Architectural Review Board

PROJECT MEMORANDUM

SUBJECT: **15 W. Strong Street**

This memorandum is to explain the timeline and scope of design changes to Building #1 (Townhouses #1-5) of the Covington Place development.

A1.0

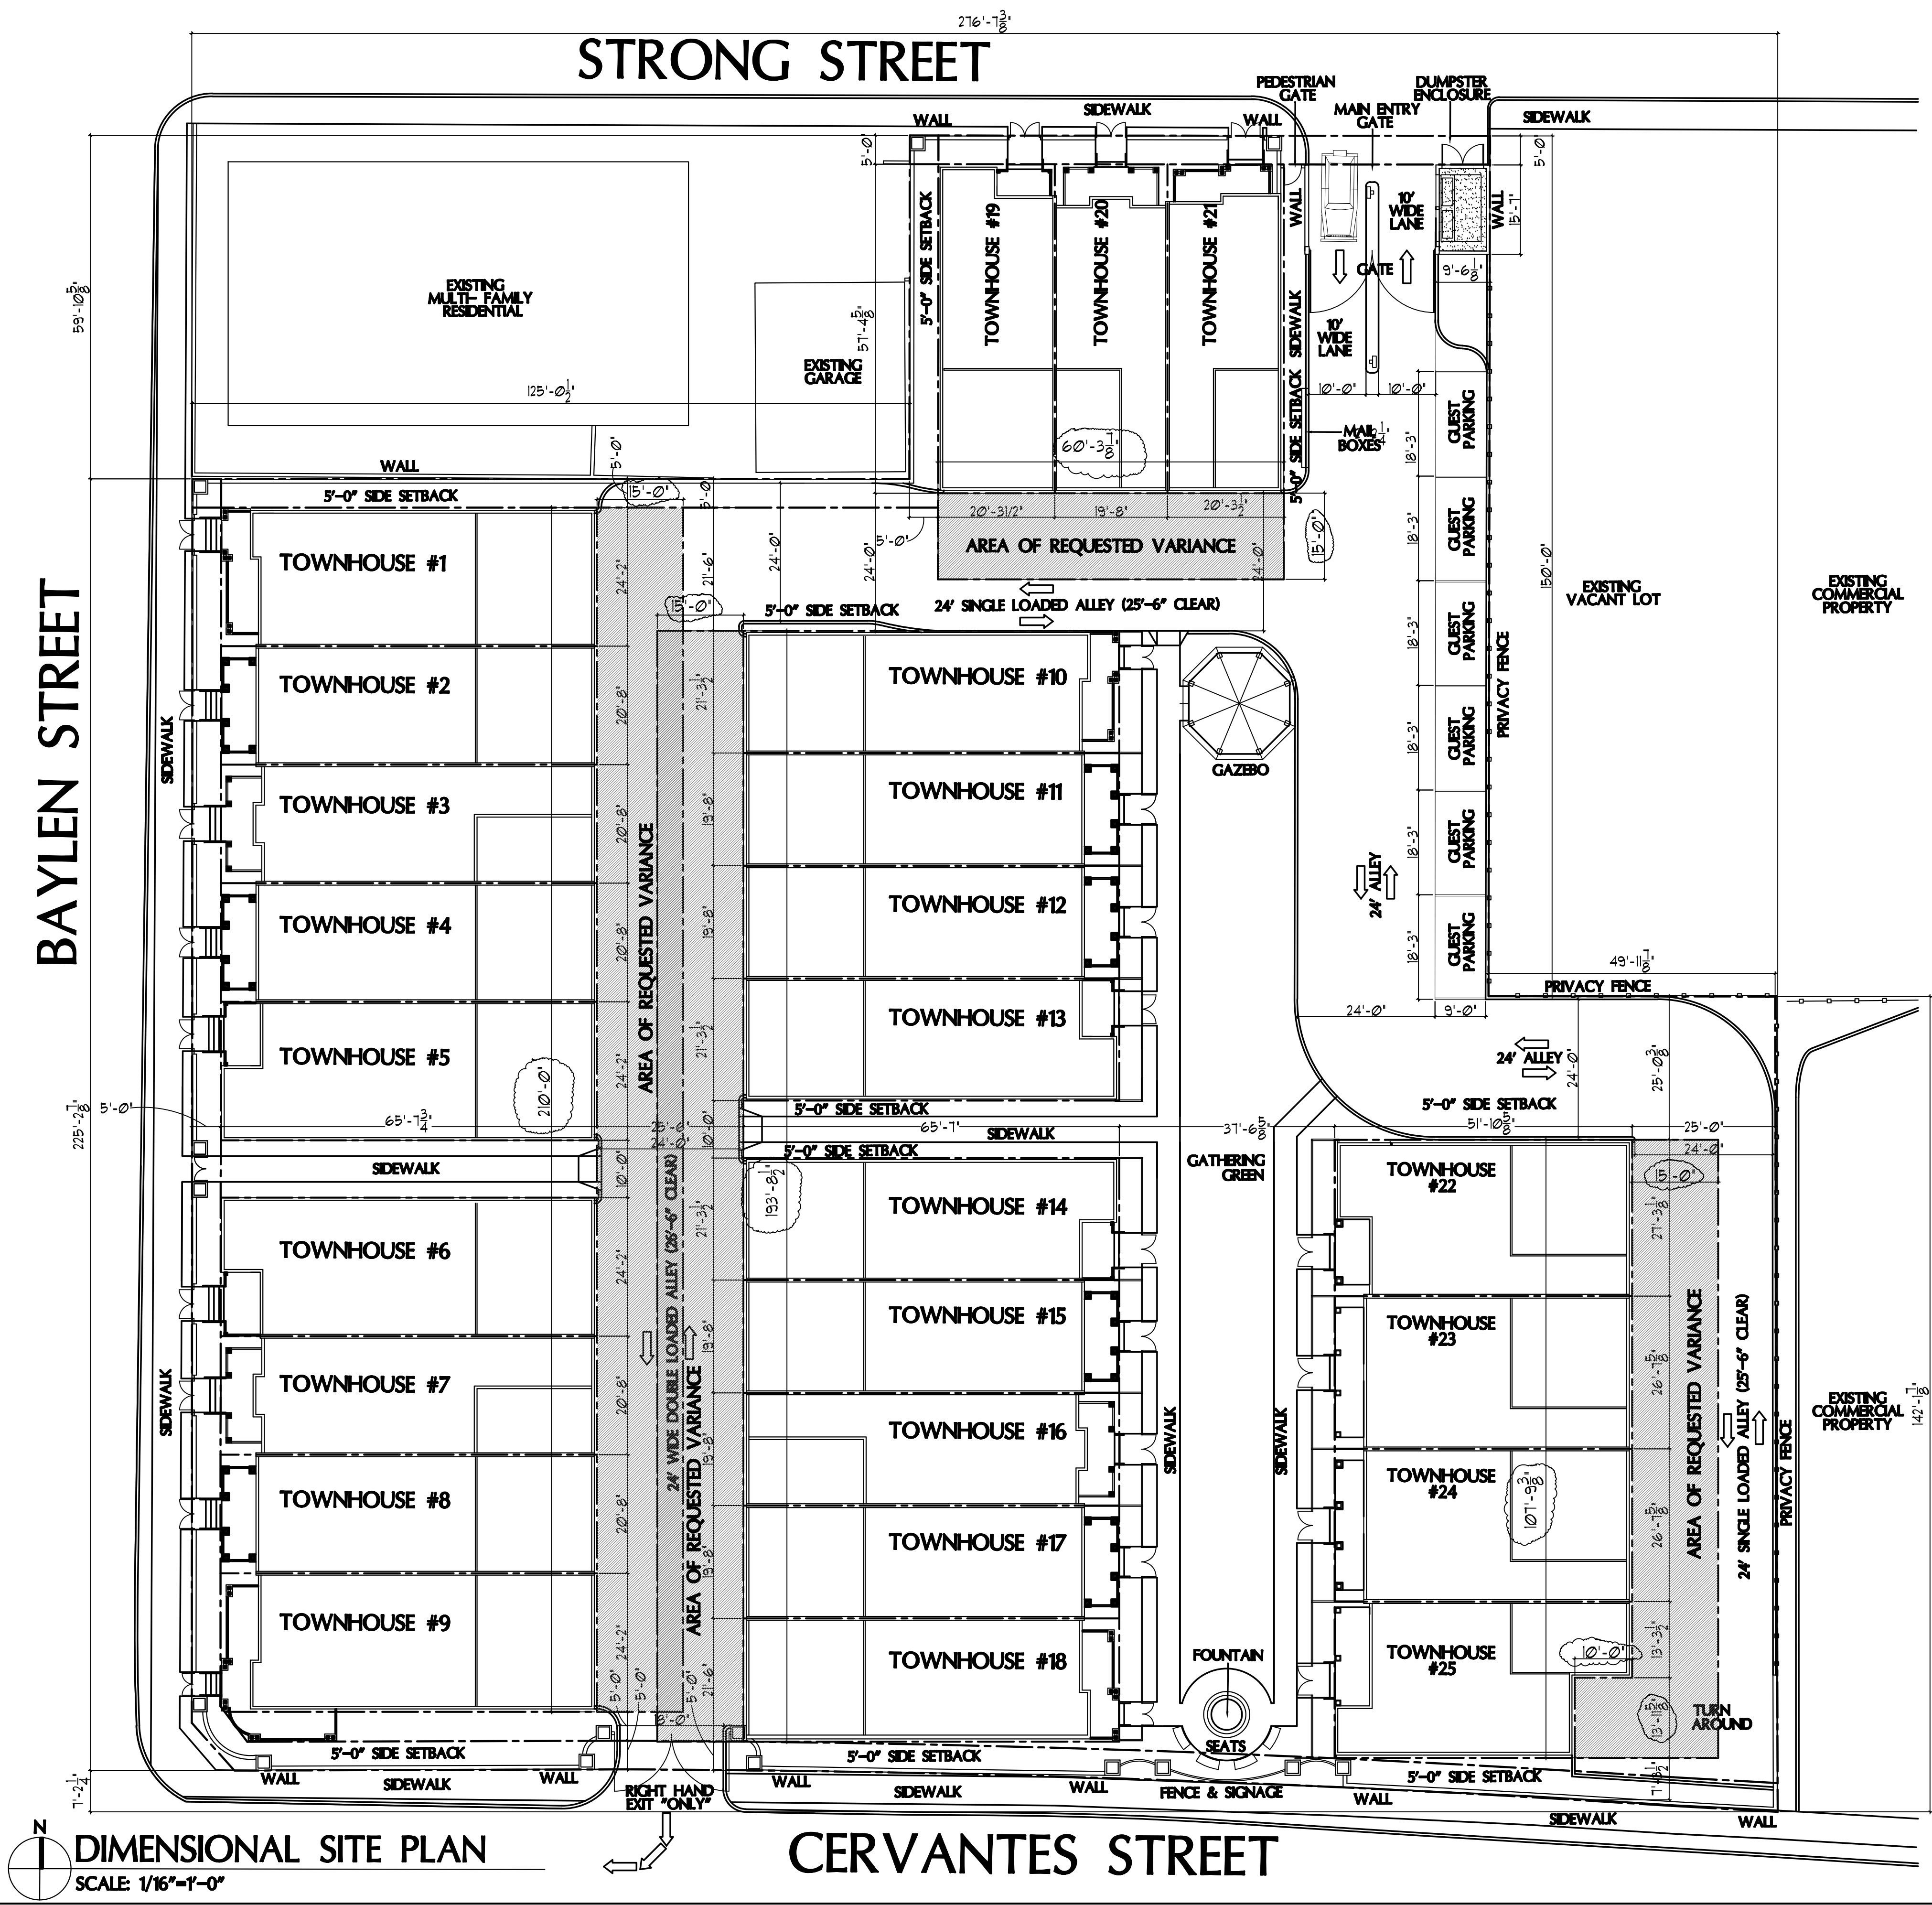
- An addition of a south facing gable for the Cervantes façade on the western most and central building ends facing Cervantes (townhouse 9 and 18); and

- Approval of a fence with brick piers and appropriate stone caps with skim-coated block or brick with some manner of planting to green the wall with ivy or appropriate vines.

Mr. Mead made a motion to approve the plan with the following changes: an addition of a south facing gable for the Cervantes façade on the western most and central building ends facing Cervantes (townhouse 9 & 18); approval of the fence with brick piers and appropriate stone caps with block or brick with some manner of planting to green the wall with ivy or appropriate vines. Ms. Campbell seconded the motion. Chairman Quina asked if the block was skim coated, and Mr. Mead clarified it would be skim coated. Mr. Jones asked about the brick pavers, and Mr. Liberis stated the actual sidewalks would be concrete, the steps and porch floor of the first floor would be brick veneer, but there could be a brick edge between the sidewalk and the front step. Also, the driveways between the units would be asphalt. Chairman Quina thanked the applicant for being transparent with the neighborhood and having a preliminary review. The motion then carried unanimously.

A3.1

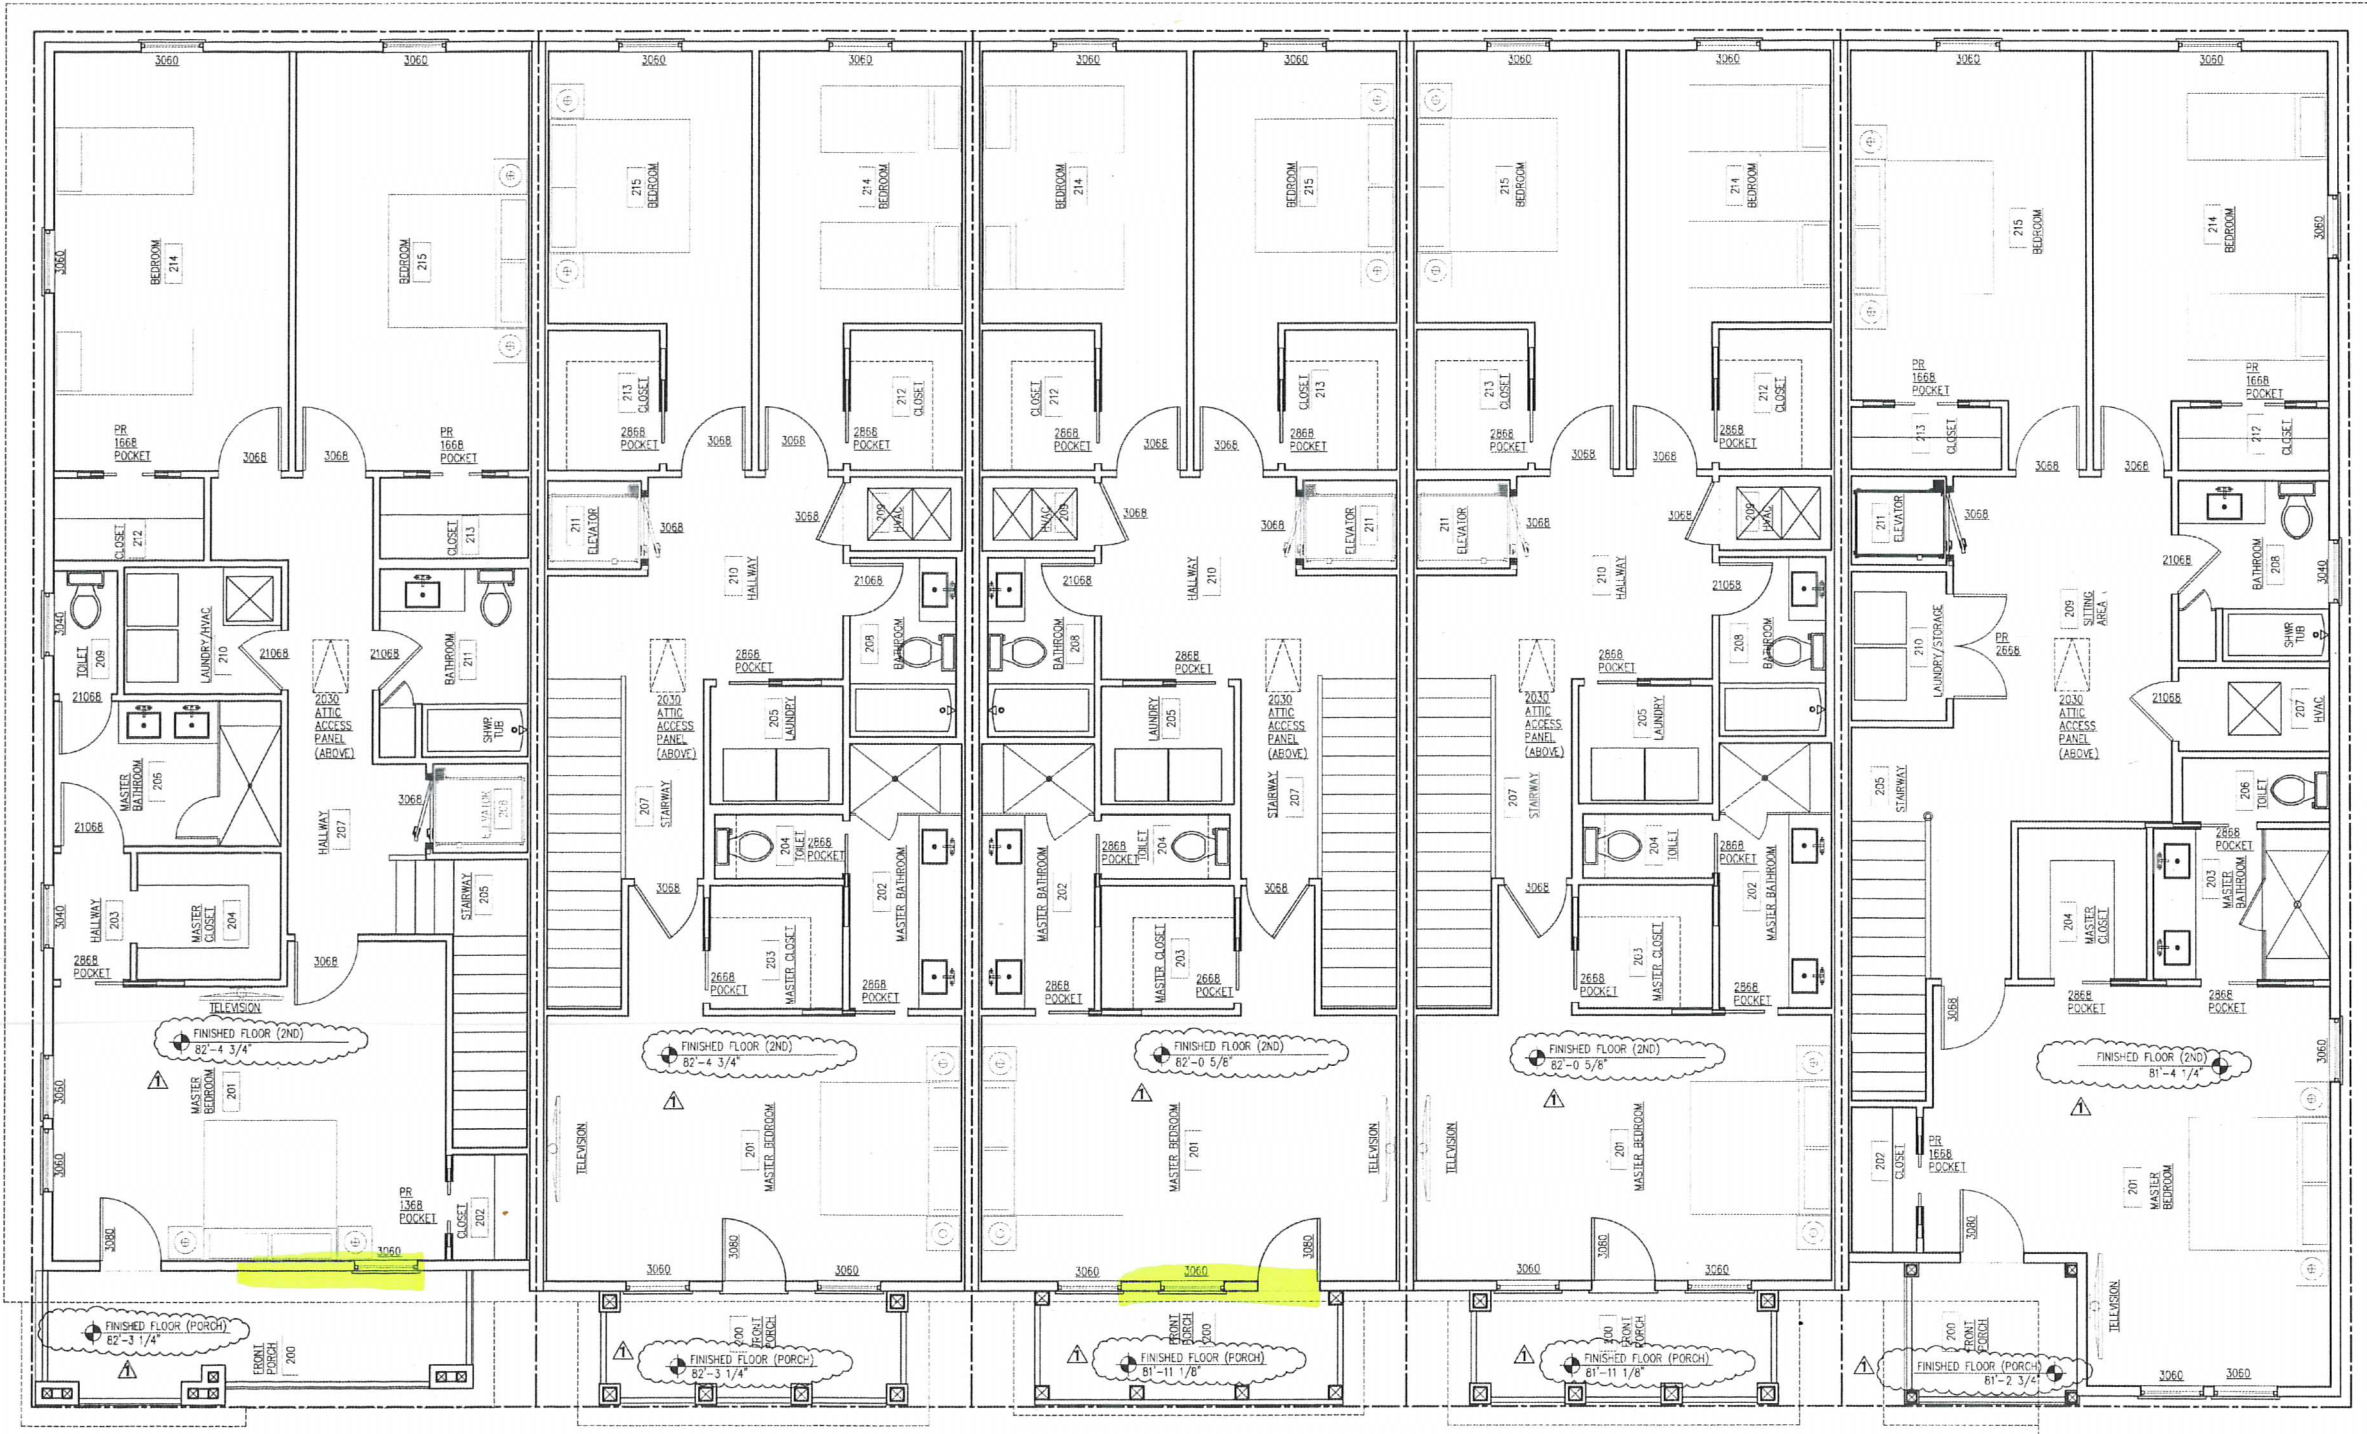
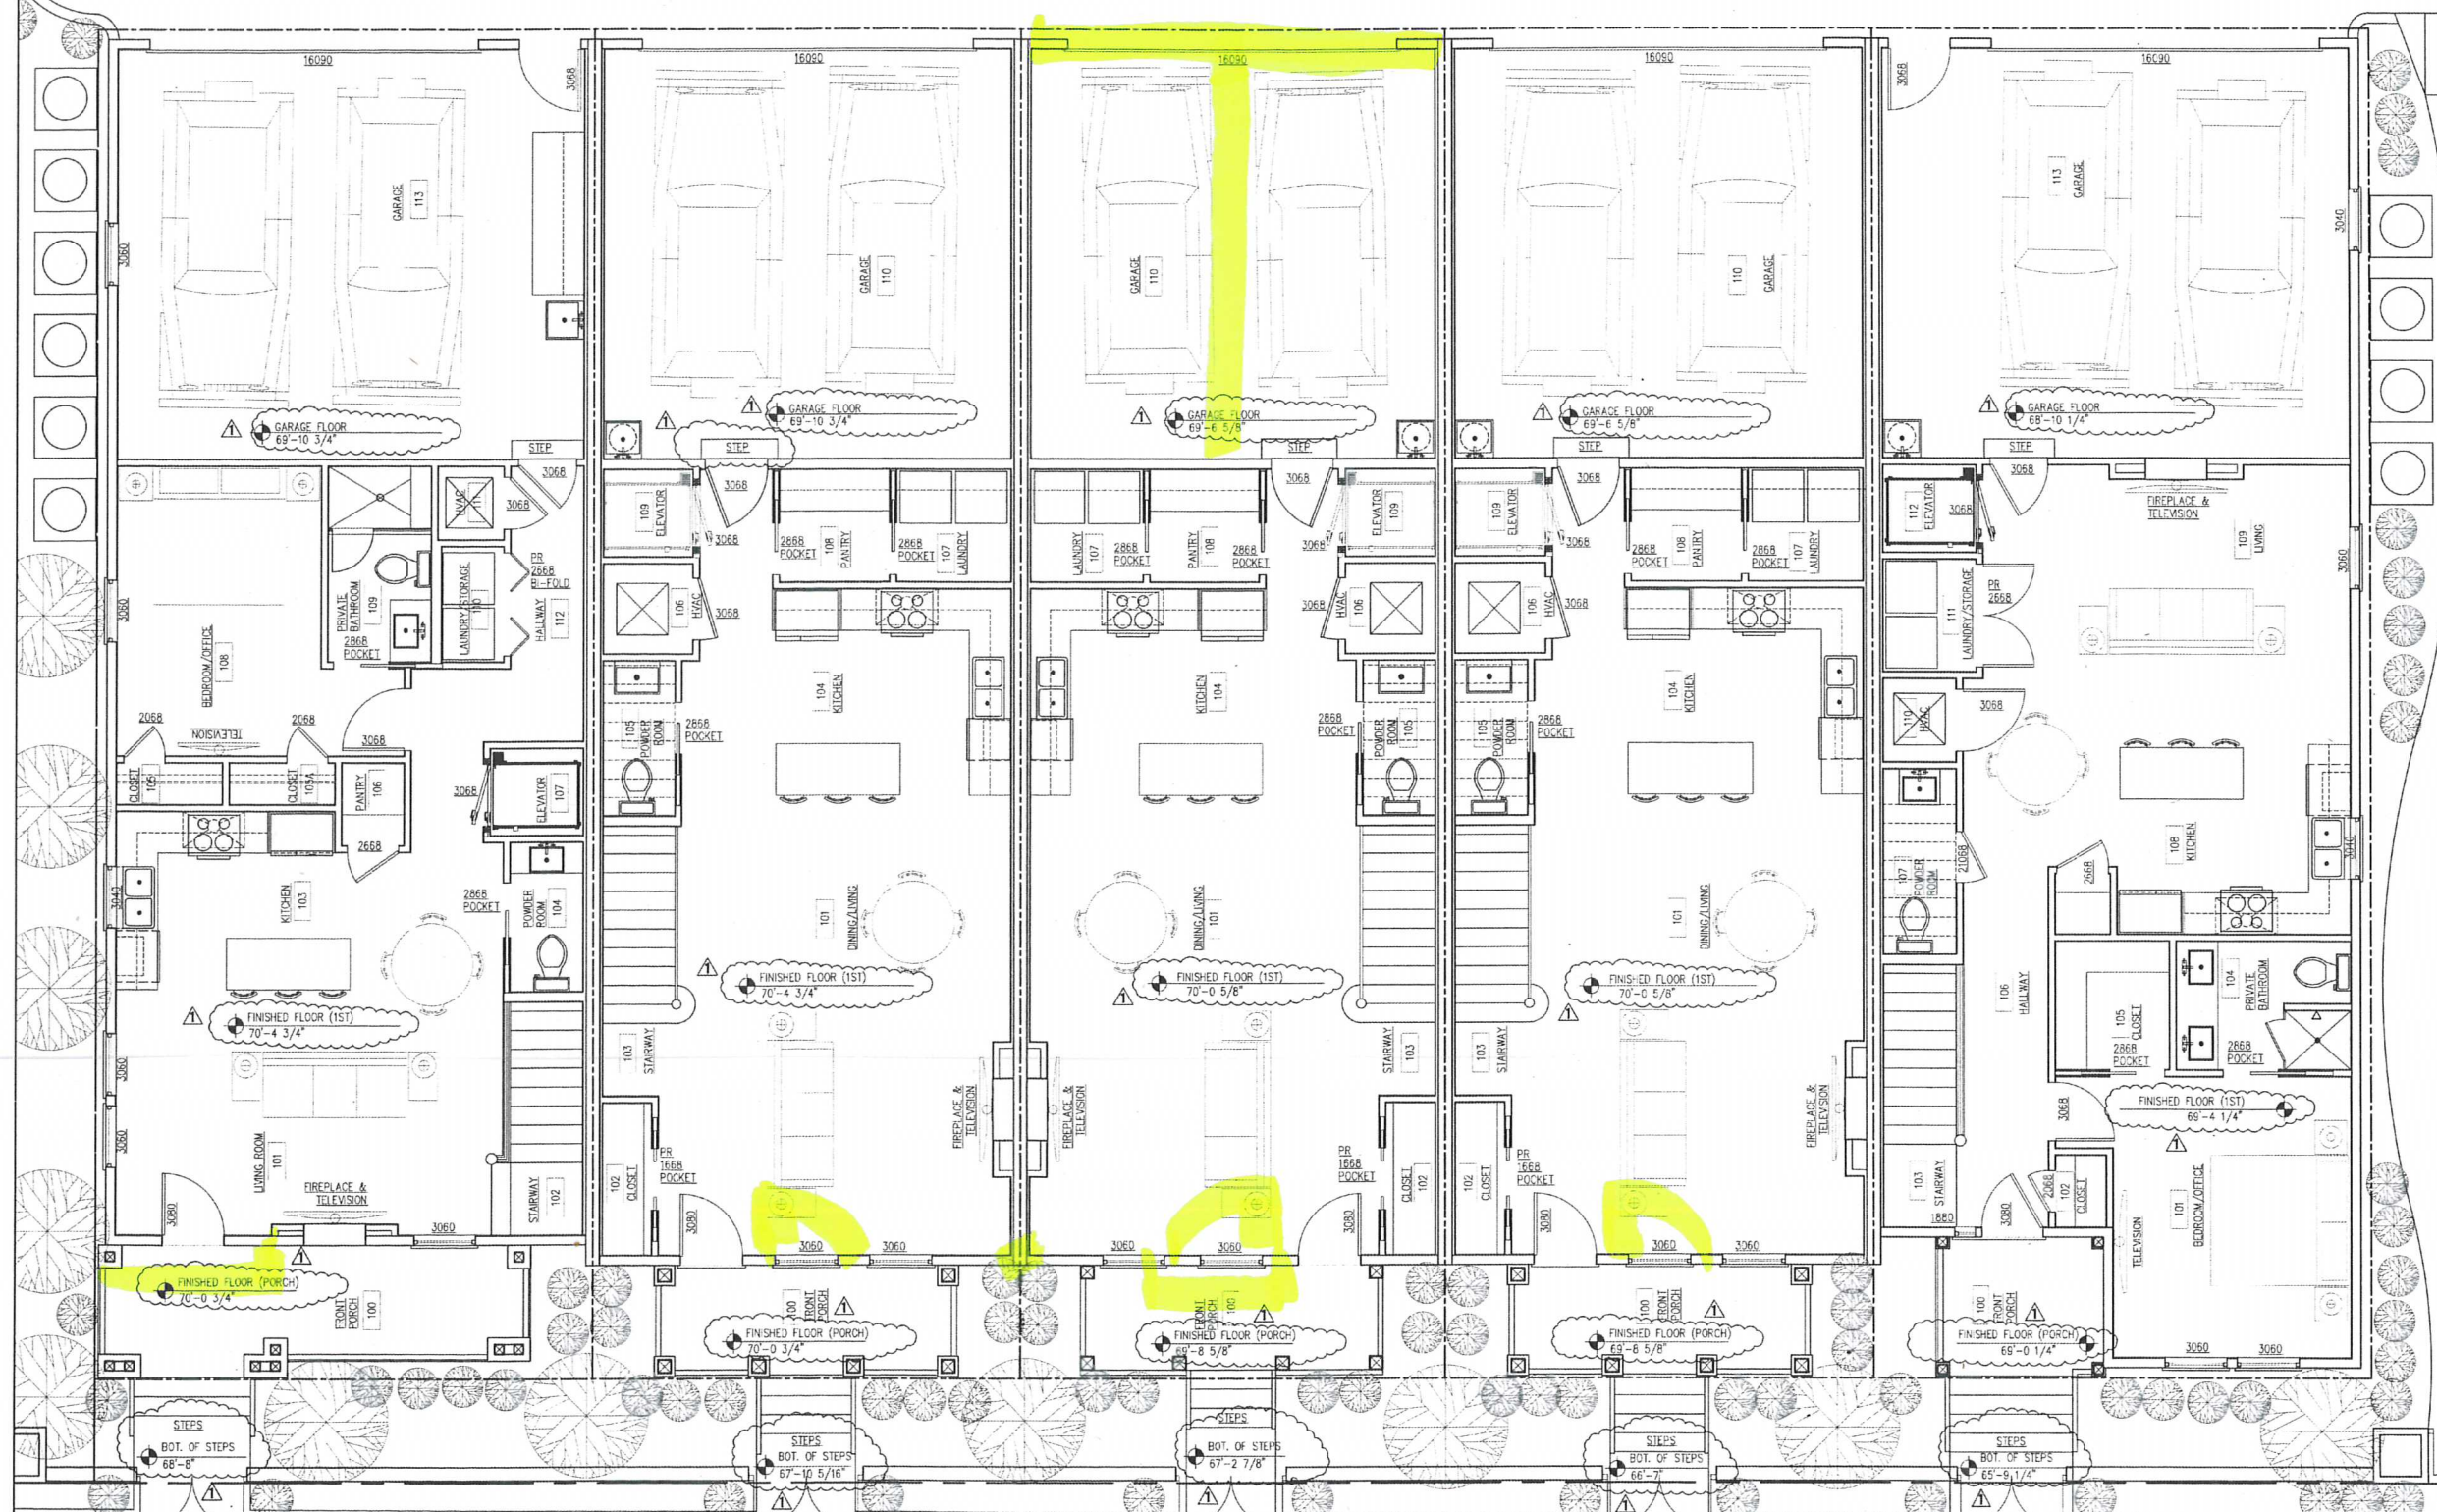
3. Construction documents for Building #1 (Townhouses #1-5) submitted to Inspection Services for review and permits in April 2018.
 - ***Design changes from ARB approval to all elevations and minor changes to floor plan are documented (major changes have been highlighted).
